SUBJECT: Submits response to RAI re reactor bldg overpressure for reactor bldg spray pumps net positive suction head. Calculations requested in Question 1 contained in Attachments 2 & 3 to ltr.

Subject: Oconee Nuclear Station, Units 1, 2, and 3  
Docket Nos. 50-269, 270, and 287  
TAC Nos. MA3765, MA3766, and MA3767  
Response to Request for Additional Information  
Related to Reactor Building Overpressure for  
Reactor Building Spray Pumps Net Positive Suction  
Head.

CHART 1

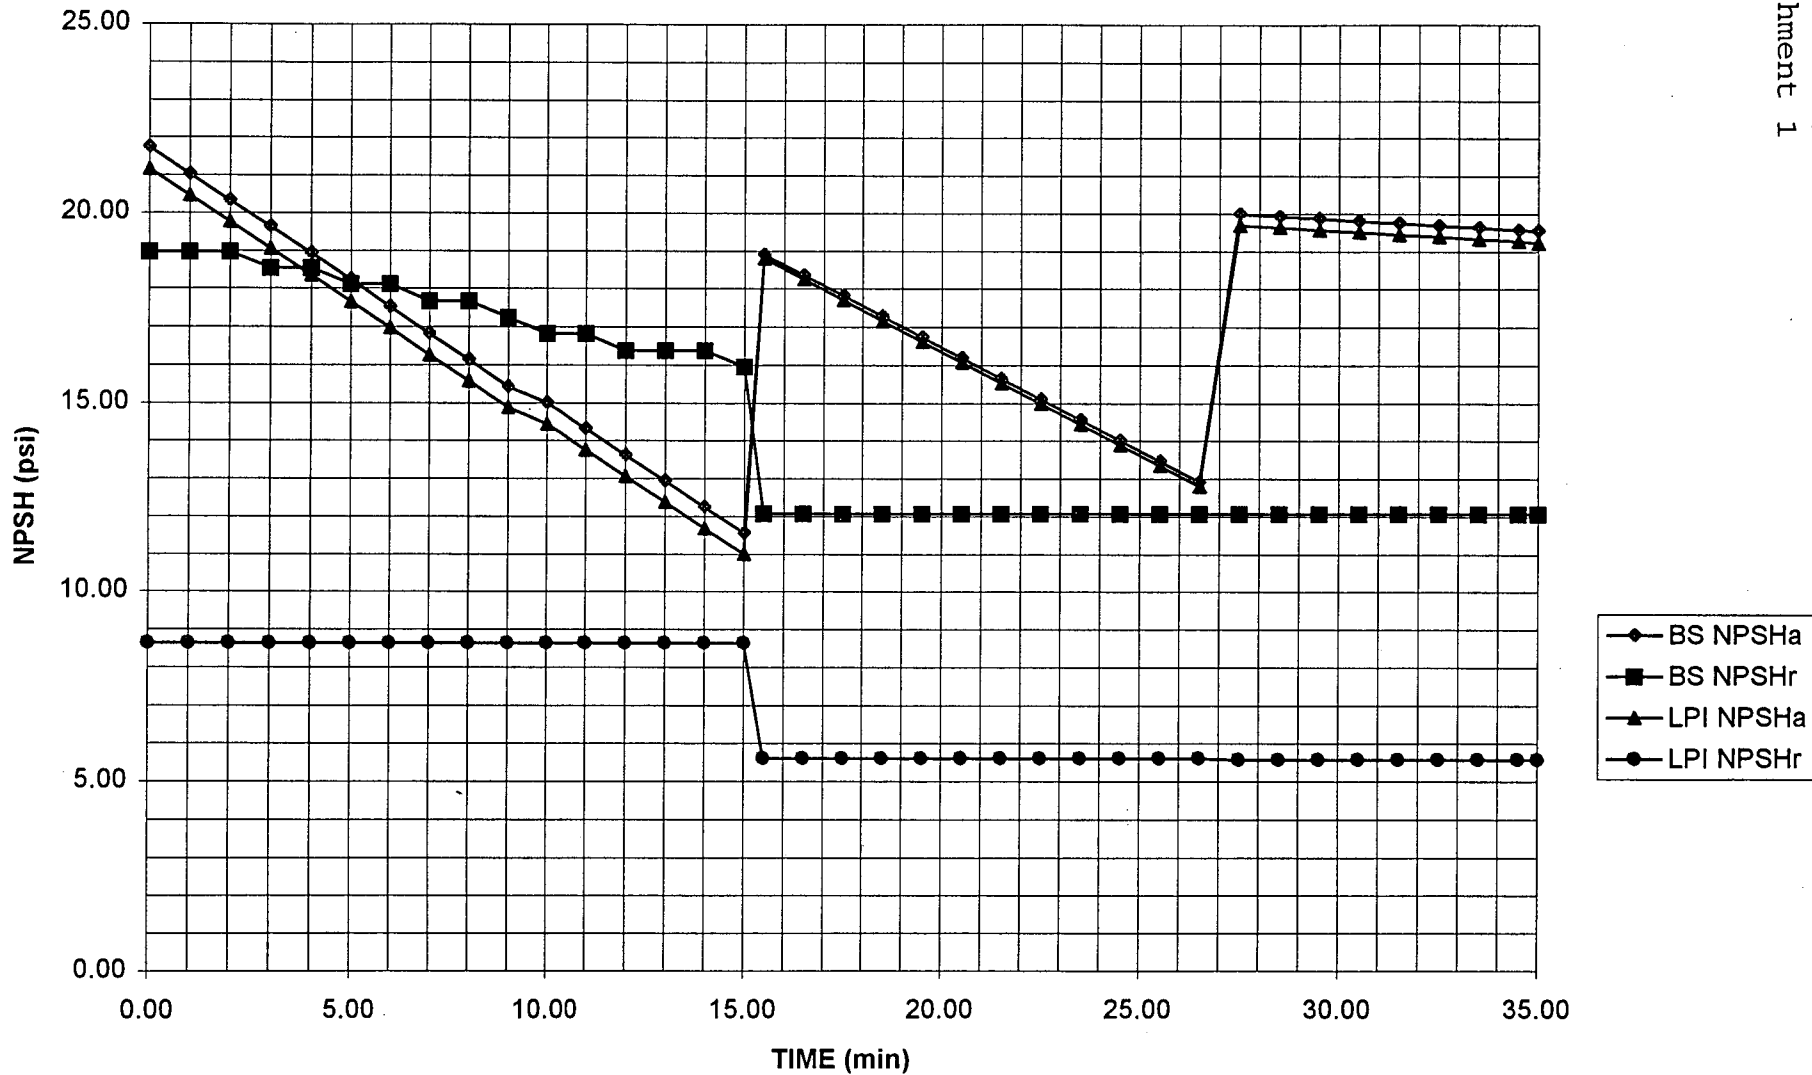
Provide a graph that depicts the NPSH required in pounds per square inch for the RBS and LPI pumps versus time and the calculated NPSH available versus time. A sample of the type of graph that is requested is provided for your convenience.

The following graphs depict the NPSH required (NPSHr) and NPSH available (NPSHa) for the RBS and LPI pumps for both the injection and recirculation phases. There are three graphs for the recirculation mode (Charts 2A, 2B, and 2C), each shows NPSH assuming a different Reactor Building Cooling Unit (RBCU) cooling capacity. The NPSH available curves shown on the graphs for the recirculation mode include containment overpressure.

There are three distinct regions shown on Chart 1 for the injection phase. These are discussed individually below:

1. The first region is from 0 to 15 minutes following the onset of the LOCA. The 'C' High Pressure Injection (HPI) pump is assumed to be throttled to approximately 500 gpm at 10 minutes into the event. No other pump throttling is assumed during this time period. Simulator testing has demonstrated that all ECCS and Building Spray pumps will be throttled within this 15 minute window. However, for analytical purposes, The Low Pressure Injection (LPI) pumps and Building Spray pumps are assumed to be throttled at 15 minutes for conservatism.

The available NPSH decreases below the required NPSH for the Building Spray (BS) pumps at approximately 5 minutes into the event. The available NPSH is approximately 4.5 psi below the required NPSH prior to throttling at 15 minutes into the event. This NPSH deficiency has been documented and evaluated under Duke's Problem Investigation Process (PIP) and reported to the NRC in Licensee Event Report (LER) 269/1998-12 submitted on November 2, 1998. The operability of the Building Spray pump under these conditions has been verified by test. Testing was performed on a pump of the same model and size as the Oconee Building Spray pumps at the pump manufacturer's facility on November 13, 1998.

2. The second region is represented by the period of time between 15 minutes and approximately 26.5 minutes. In this region, LPI pumps are throttled to 3000 gpm indicated flow, BS pumps are throttled to 1500 gpm indicated flow, and HPI pumps are assumed to operate throttled to 1500 gpm indicated flow. This region ends at a Borated Water Storage Tank (BWST) level of approximately 6 feet, when the transfer of pump suction source from BWST to Reactor Building Emergency Sump (RBES) is initiated. When throttling occurs at 15 minutes, the required BS NPSH is again satisfied, as the

3. The third region represents the time from the beginning of swapover (approximately 6 feet BWST level indicated) to the end of swapover (approximately 2 feet of BWST level indicated). When a BWST level of 6 feet (indicated level) is reached, HPI pumps are secured and sump isolation valves are opened. Flow from the BWST is substantially reduced when the HPI pumps are secured. There is an accompanying increase in available NPSH for the BS and LPI pumps due to the reduced friction losses at lower flow rates. Also, the opening of the sump isolation valves significantly reduces flow from the BWST, as flow begins to split between the sump and the BWST. This reduction in flow from the BWST also raises NPSHa due to the lower friction losses in the supply lines from the sump. At or before reaching a level of 2 feet (indicated) in the BWST, the BWST isolation valves are closed, and the injection phase of the event is terminated at approximately 35 minutes.
